DOOSAN Document Transmittal Upper Trishuli-1 HEP (216MW)		Date 2022-08-12	DT No.: UT1-HEP-DHI-PC-D-0057	SHEET 1 OF 1
DOOSAN NEPAL BRANCH OFFICE	Address & Contact No. : Four Square Building, Naxal, Kathmandu, Nepal (P.O Box : 1387) + 977 1 692 3014	Project No. H20002	DOCUMENT DISPATCHED BY Courier Service ☐ Messenger ☐ Post-Air Freight ☐ Document System or E-mail ■ By hand ■	
DOCUMENT DISTRIBUTION	■ POWER CHINA (Subcontractor) ☐ Doosan's Site Office			
SUBJECT	Review Note RN-0215_Layout DWG of Desander Basin

REVIEW NOTE

Contractor	**Doosan Enerbility**		
Title of the Document	Layout Drawing of Desander Basin		
Document/Drawing No.	UT1-C-030-CVL-DG-52001	Revision	0B
Date of Documents/Drawings	28.07.2022	Received Date	01.08.2022
Transmittal Form No.	UT1-HEP-DHI-D-0329		
Previous Review Date/Status	20.10.2021/RR	Prev. Review Note No.	RN-0019
Review Note No.	**RN-0215**	**Present Review Date**	**12.08.2022**
		Present Review Status	**AN**

DRAWING TITLE
LAYOUT DRAWING OF DESANDER BASIN

SECTION H-H
1:100

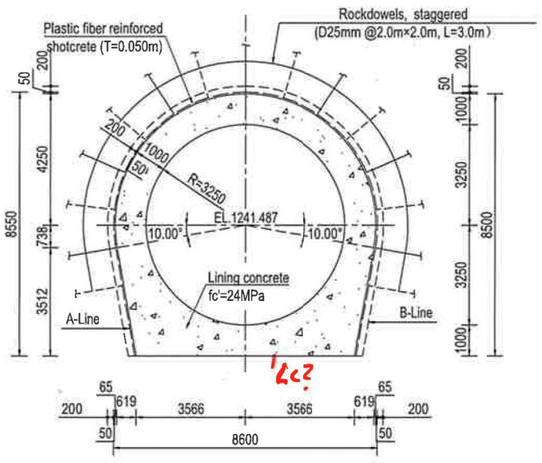
LC?

SECTION J-J
1:100

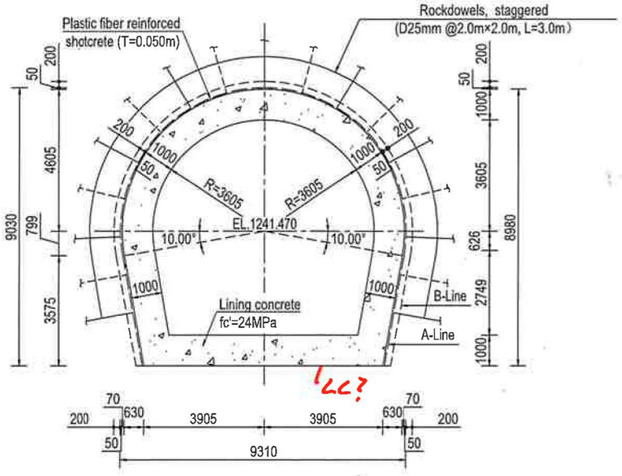
LC?

SECTION M-M
1:100

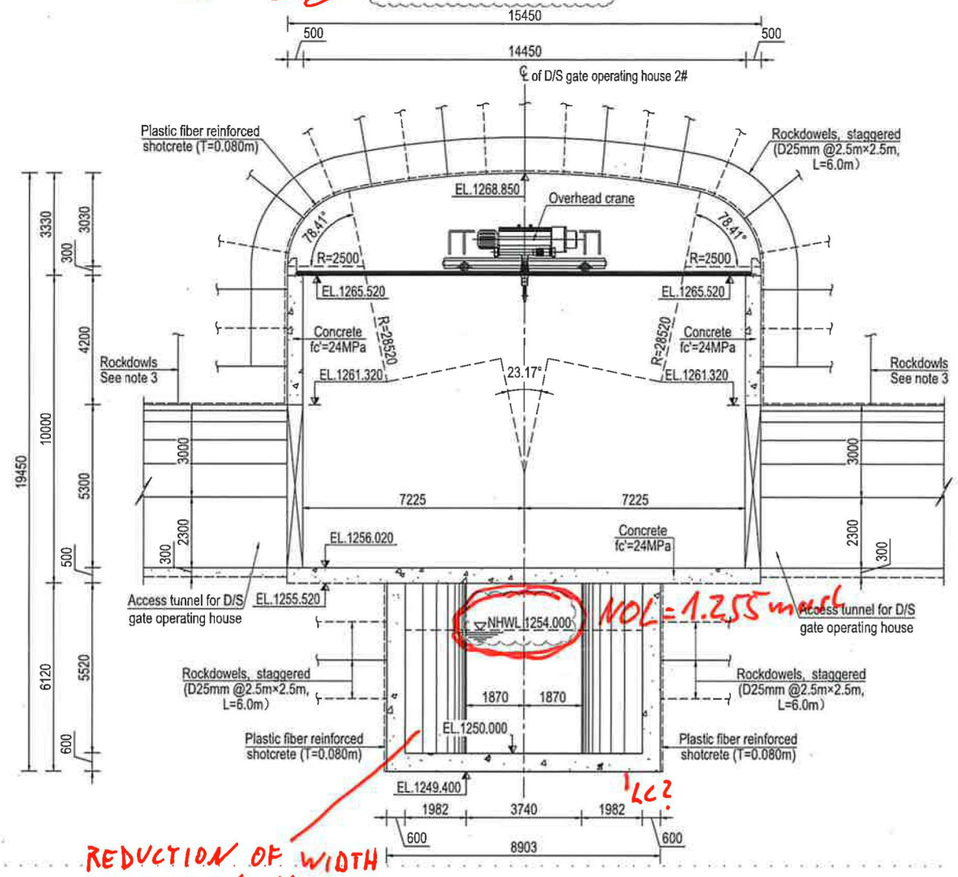
REDUCTION OF WIDTH NOT SHOWN IN GENERAL PROFILE (SHEET 2/6)
